FILE NO.: HDC2025-004

NAME: Narkinsky House - Certificate of Appropriateness

LOCATION: 515 S. Rock Street, Little Rock, AR 72201

**A. PROPOSAL/REQUEST/APPLICANT’S STATEMENT:**

Figure 14. 515 S. Rock Street, historic plaster porch ceiling revealed, close up, 2024.

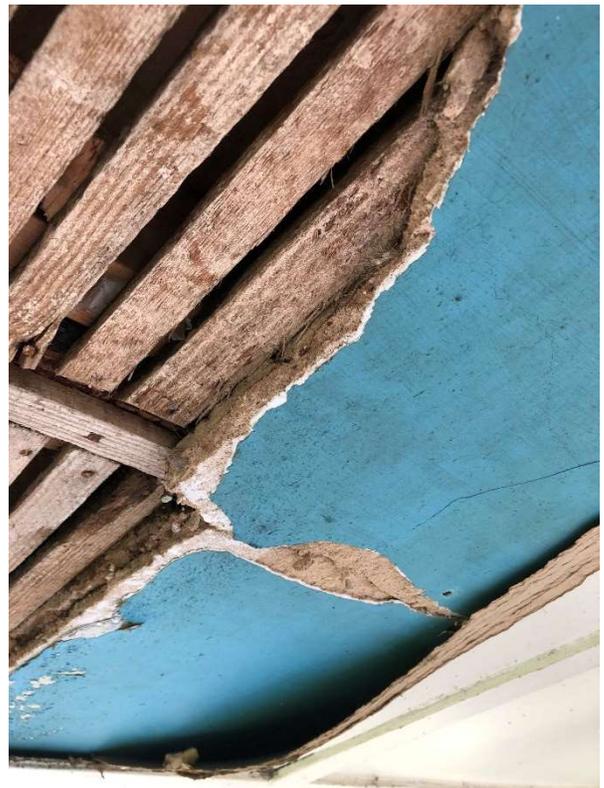
will be replaced (Figure 16), and the porch ceiling will undergo plaster repair (Figure 13, 14). Lastly, the non-original horizontal support beams attaching the columns to the front façade wall will be removed (Figure 15).

Staff finds the reconstruction of missing or altered architectural elements based on physical and pictorial evidence (Attachment D) to be consistent with Guideline 4.13(4). The proposed reconstruction of the missing architectural elements—porch foundation, metal roofing, flooring, column realignment, eave brackets, fascia—are supported by the Narkinsky family photos, the Sanborn maps, and the physical evidence assessed on site. Additionally, the proposed porch handrail is consistent with Guideline 4.13(7) and is simple and subordinate in design and compatible with the historic attributes of the property. Staff finds wood to be the most compatible material for the reconstruction of the front steps, based on pictorial evidence.

1. Chimneys: The location and design of the reconstructed chimneys will be based directly on physical and documented evidence. Chimney flashing to be installed in step pattern in the mortar joints of the masonry. Brick masonry and mortar will match existing in dimension, scale, color, texture and other physical attributes.
2. Sidewalk: Reconstruction of the brick masonry sidewalk will be based directly on documented evidence. Additional engineering review and inspection is required by the Planning & Development Department to assure that the resulting sidewalk meets relevant accessibility and environmental codes.
3. Exterior Porch Light: New lighting will conform to Guideline 9.22 and require final review and approval by the staff.
4. Rear porch steps will be constructed of wood or concrete.
5. Front porch steps will be constructed of wood.
